TECHNICAL NOTEEdition Anglaise

AUGUST 1998 77 11 201 379 **3049A**Service 0422

CENTRAL COOLANT TEMPERATURE MANAGEMENT

• Engine: D7F - E7J - K7M Basic manual: M.R. 305 - M.R. 325

2nd generation (GCTE 1)

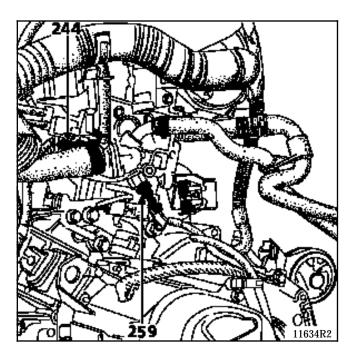
Coolant temperature switch for engine cooling fan (248) no longer fitted.

For information on other vehicles, the purpose of the modification is so that it will no longer be necessary to fit the dual function temperature switch (251) (warning light and indication of coolant temperature on instrument panel) and to replace it by a coolant warning temperature switch on the instrument panel (259). The TWINGO did not have a temperature indicator on the instrument panel originally, although a sensor (259) was already fitted.

3rd generation (GCTE 2)

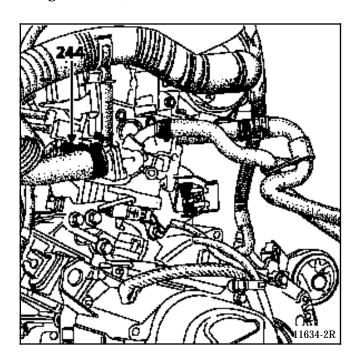
It will no longer be necessary to fit the temperature switch for the engine cooling fan (259), linked to the warning light on the instrument panel.
